**Re: Second Submission Review** – Green Valley Ranch East Site Plan No. 17 - Site Plan with Adjustment and Plat  
Application Number: **DA-1662-28**  
Case Number(s): 2022-4034-00; 2022-3032-00

On behalf of Oakwood Homes, Aztec Consultants, Dewberry Engineering and Terracina Design, we have reviewed the comments dated June 14, 2022. The following is a response to comments.

# GREEN VALLEY RANCH EAST FILING NO. 17 SITE PLAN

April 19, 2022

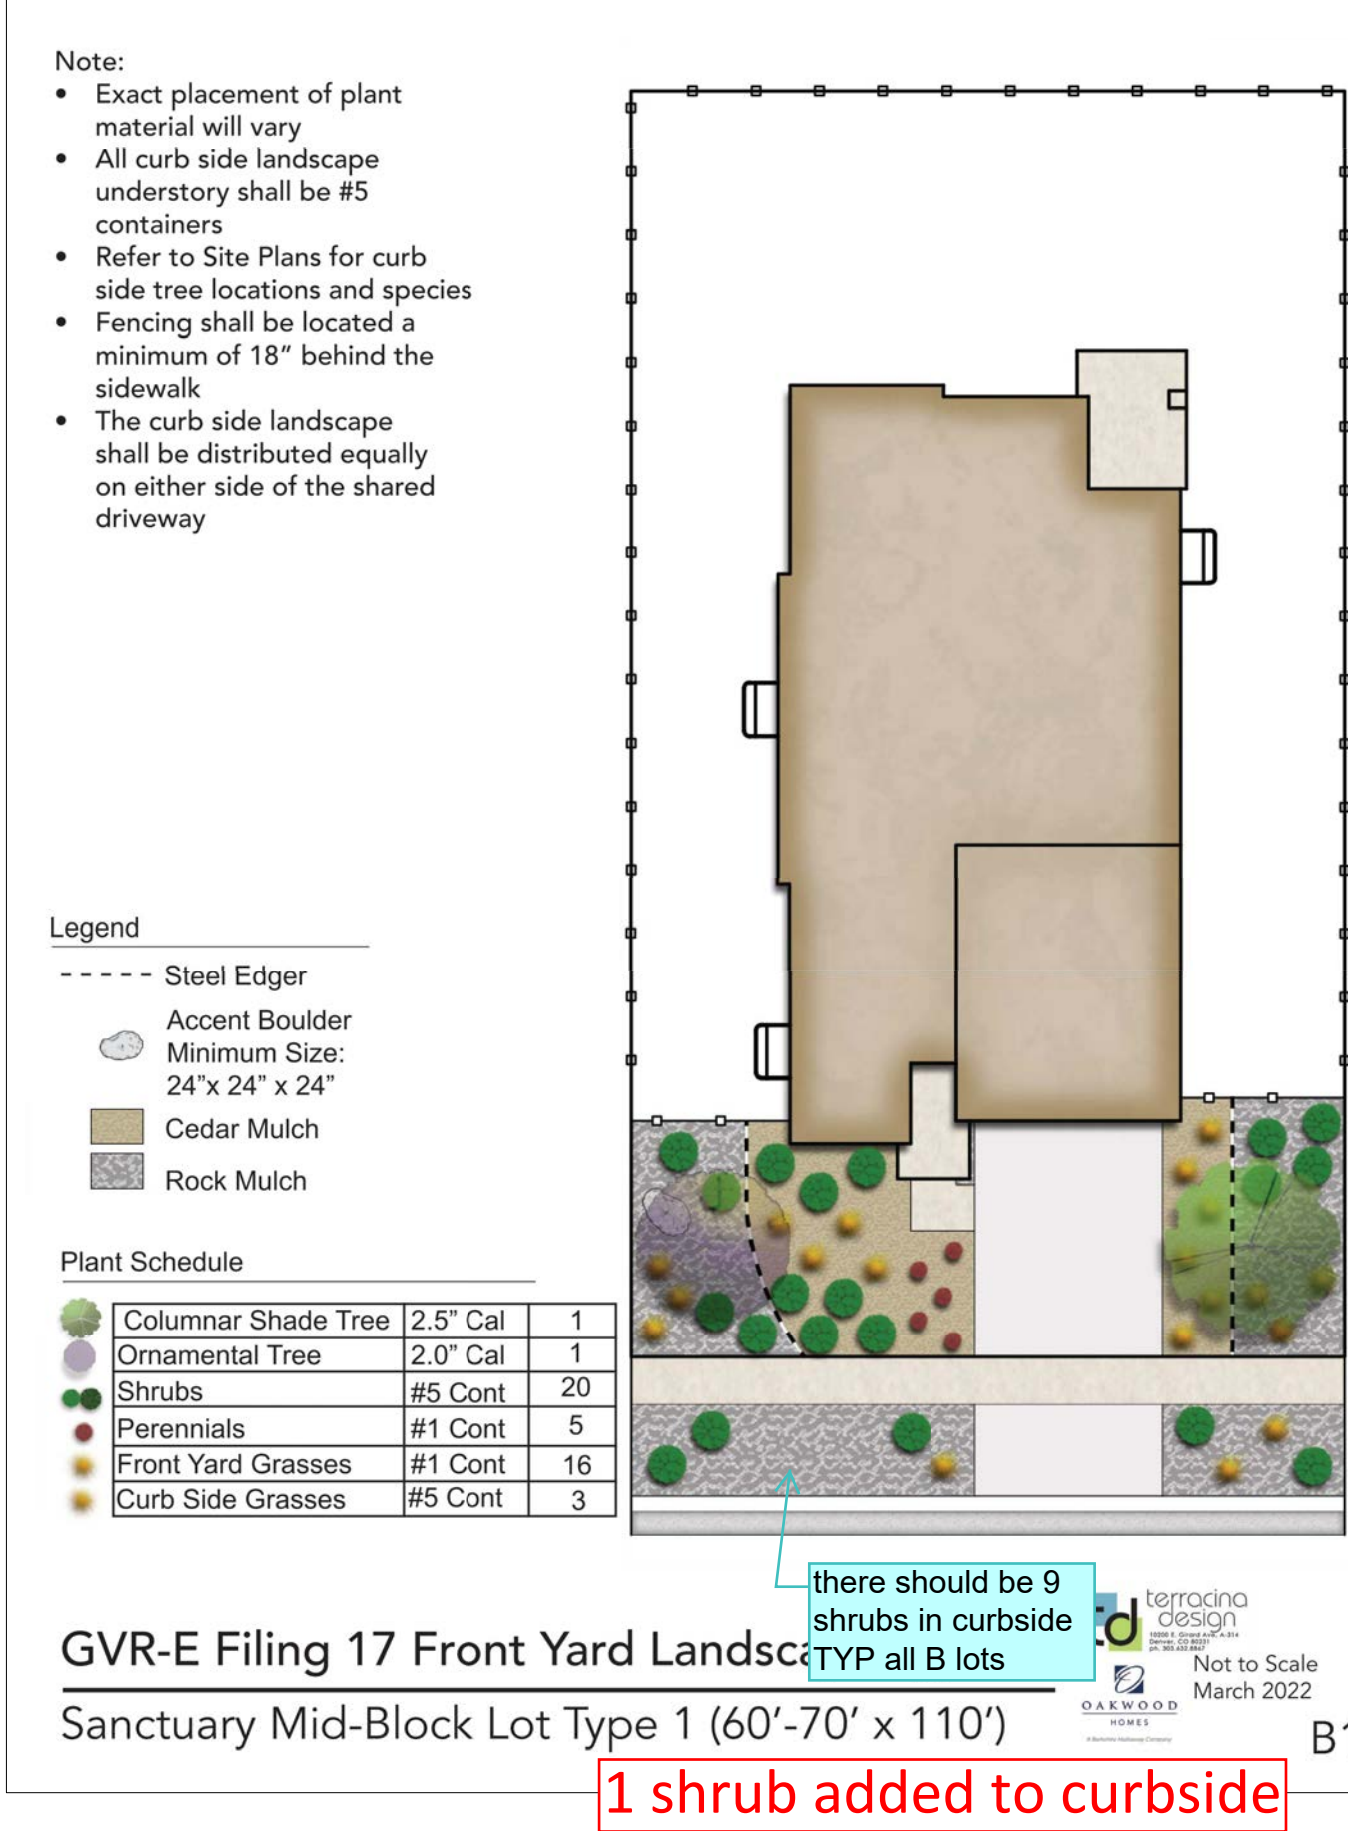
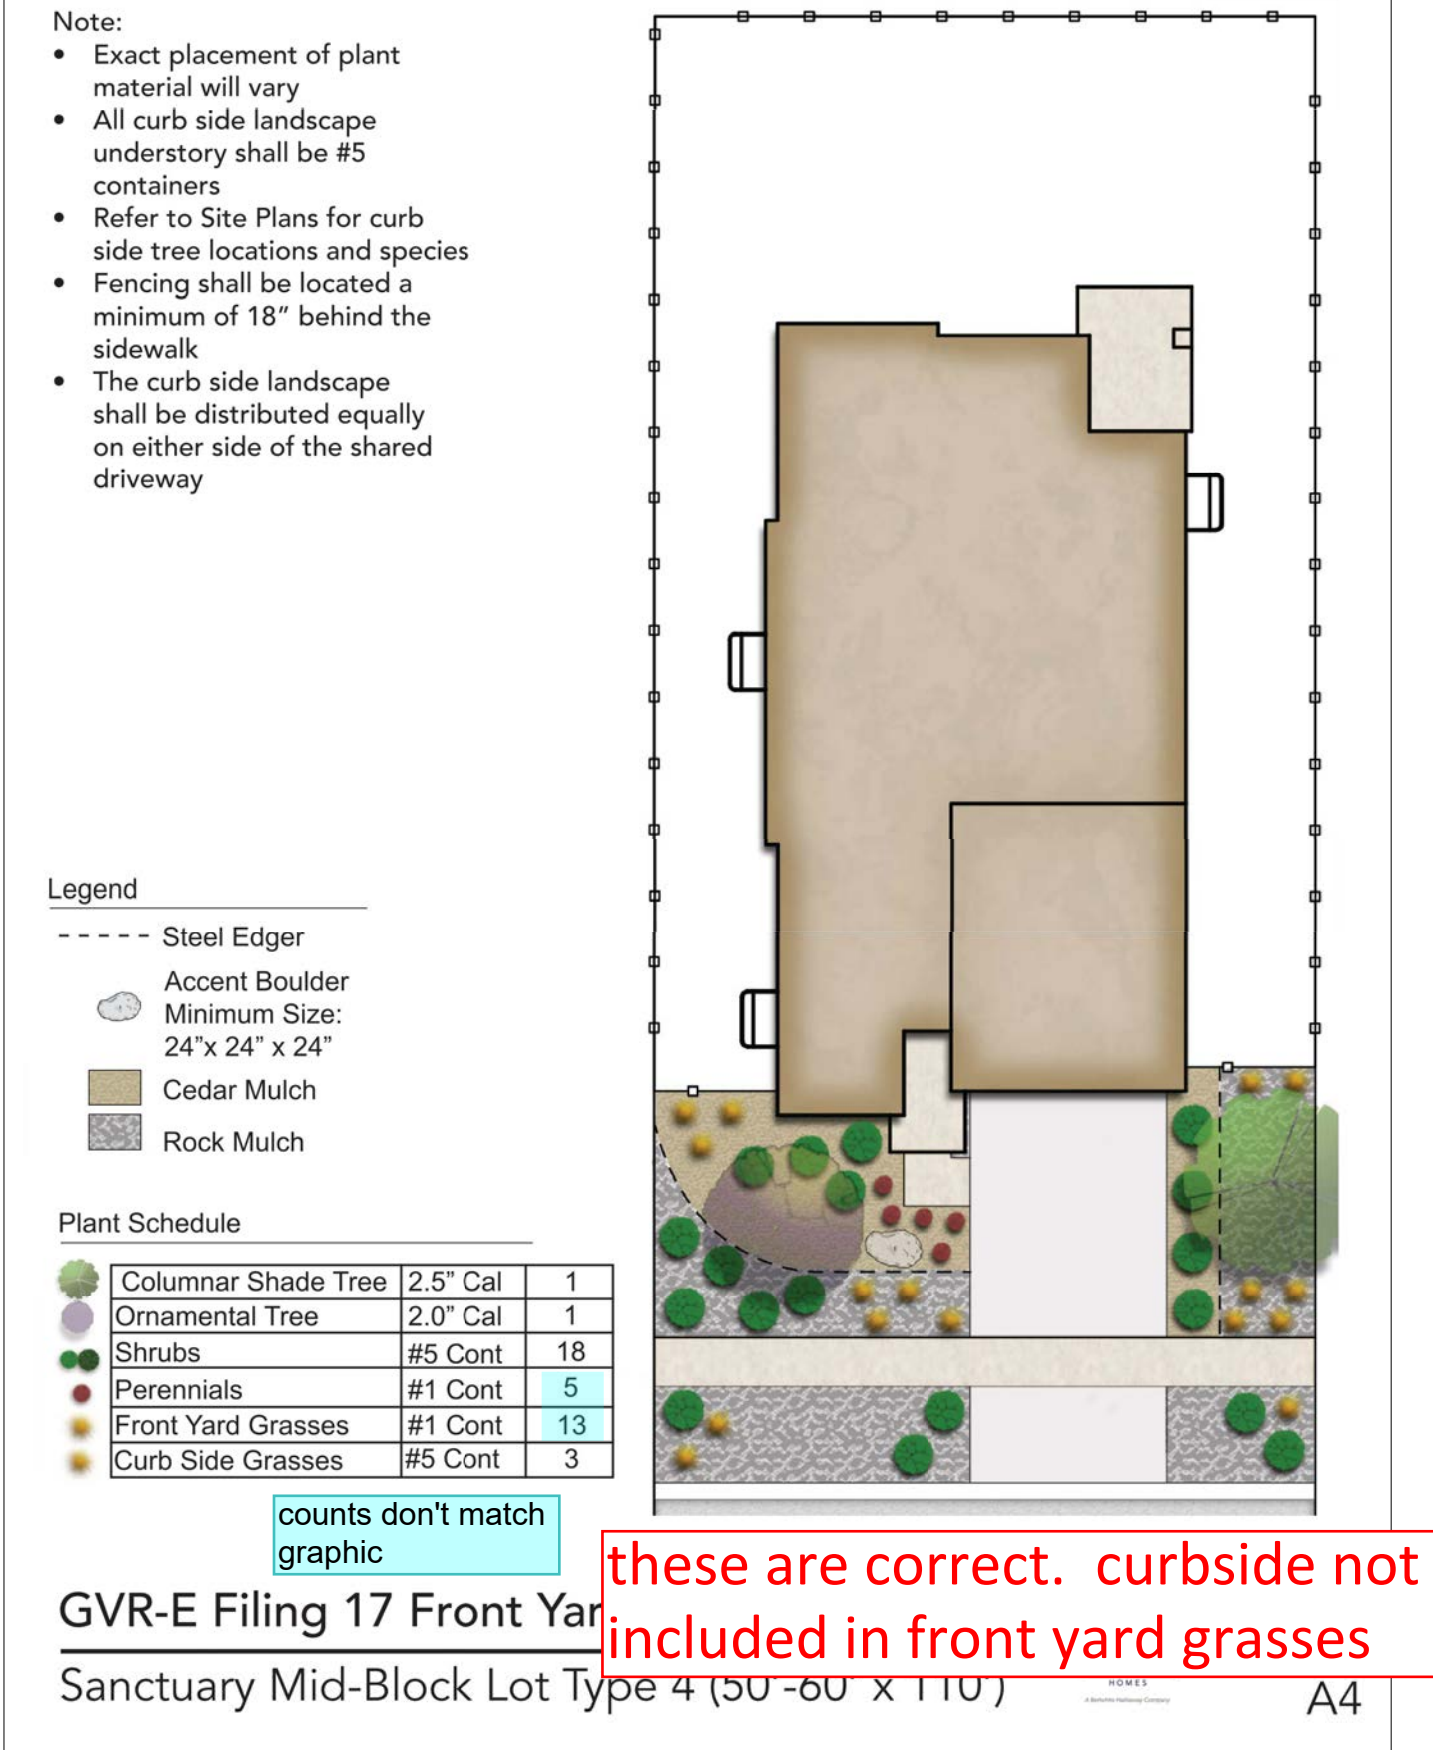
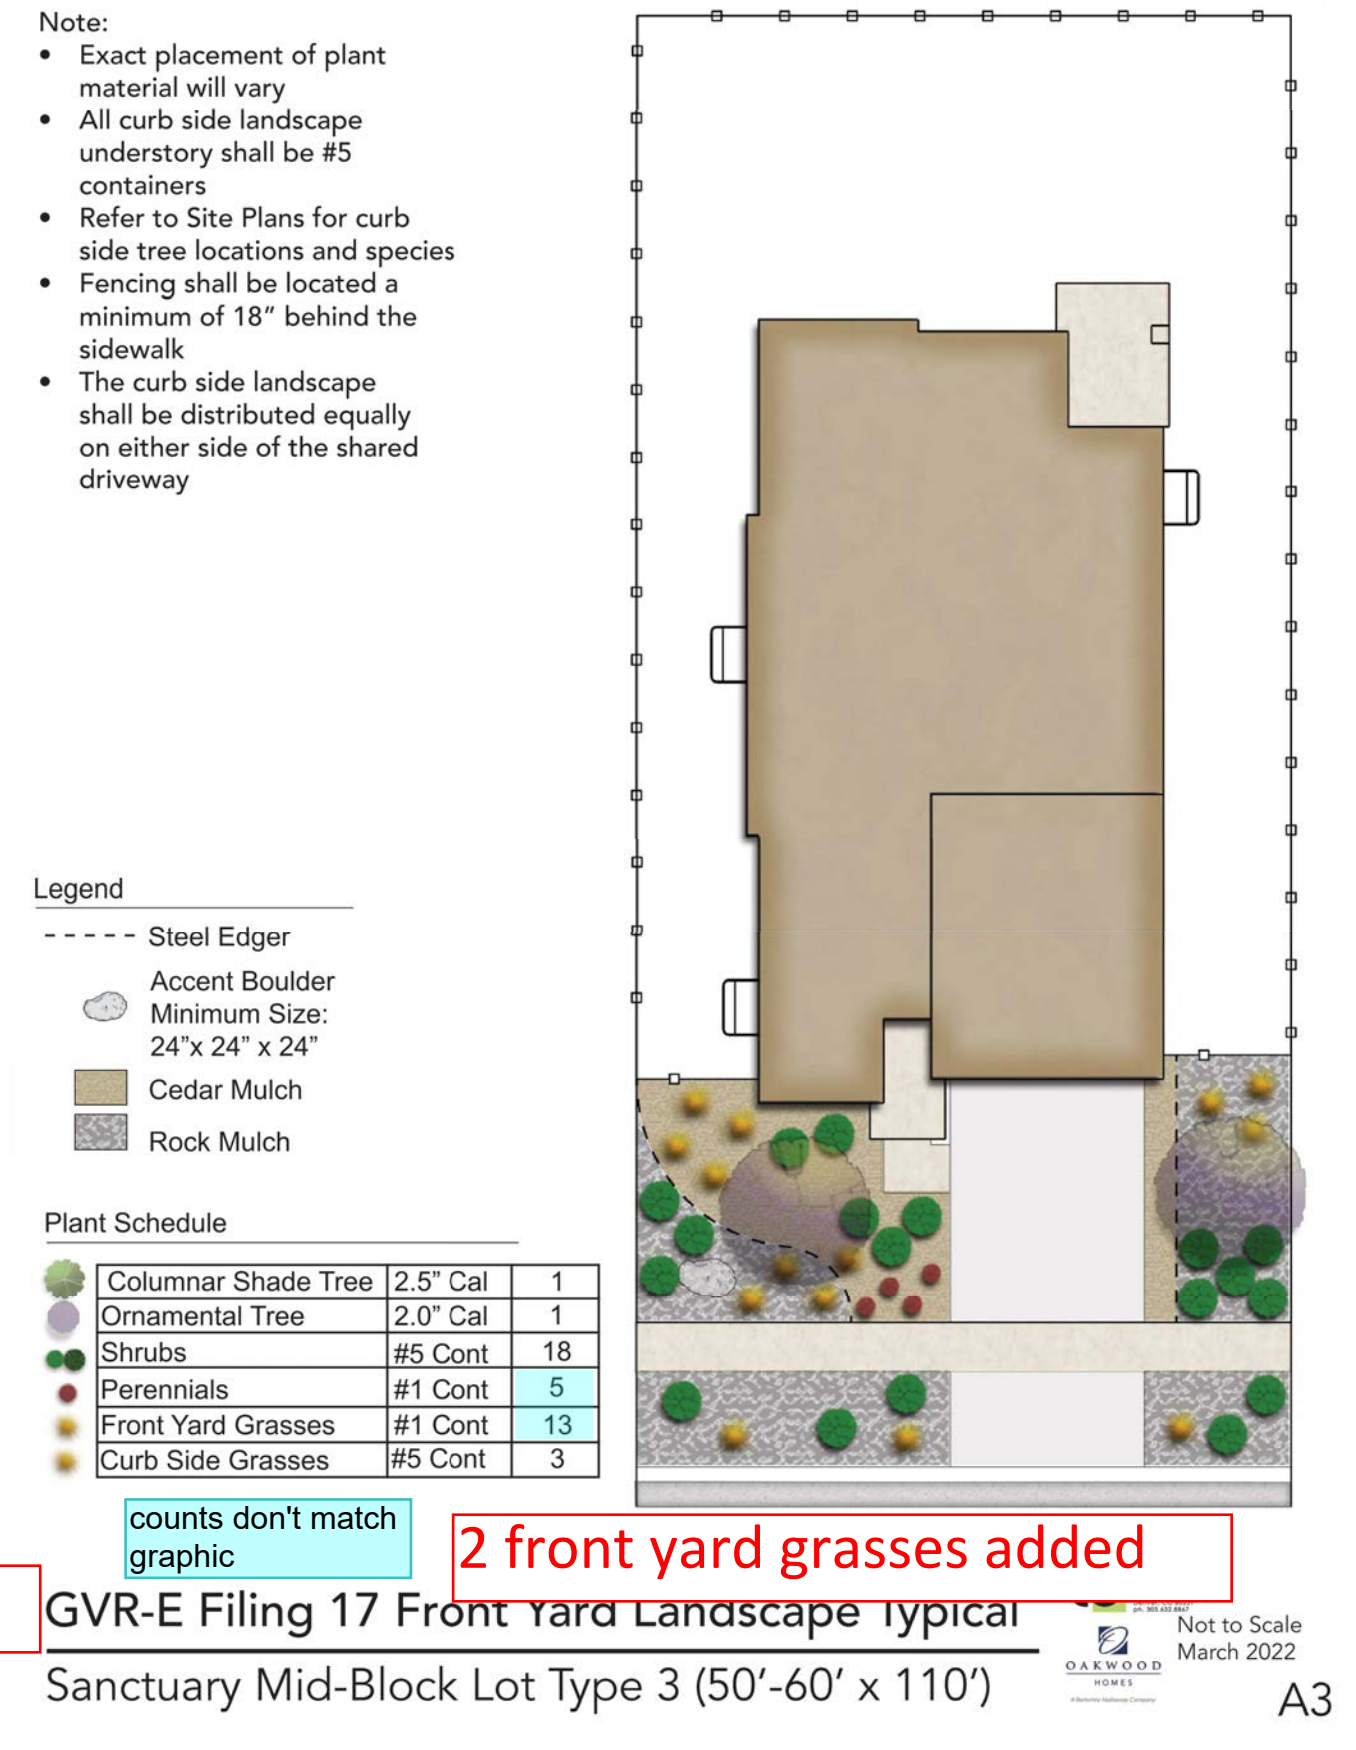
show any fencing alternatives on these plans
